WOLF CREEK

ET 18-0019

Subject: Docket No. 50-482: Supplement to Request for Additional Information Regarding the License Amendment Request for Addition of New Technical Specification 3.7.20, "Class 1E Electrical Equipment Air Conditioning (A/C) System"

Supplement to Response to Request for Additional Information

Figure 42: Case 3 - 'A' Train Room Temperatures (Air) (3301, 3407, 3408, 3413, and 3414)

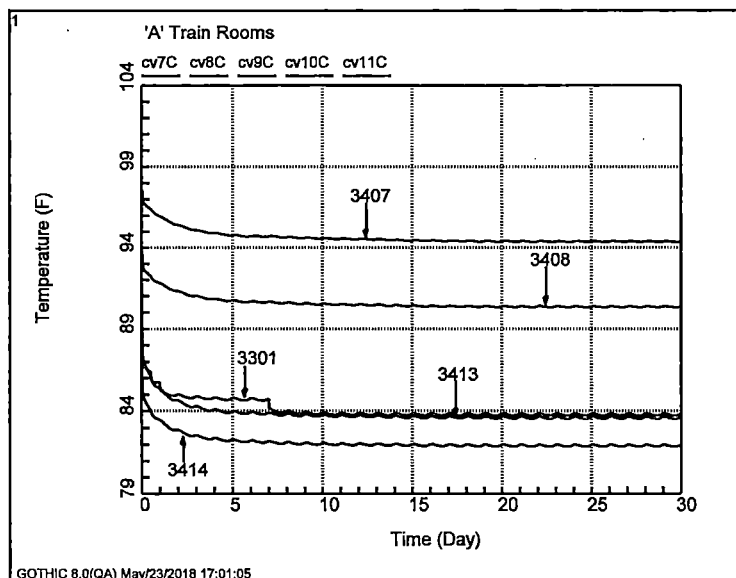
Figures 42, 43, 53 and 54 in Reference 1 provided results from Cases 3 and 4. Updated figures from calculation GK-M-016, Revision 2, are provided below.
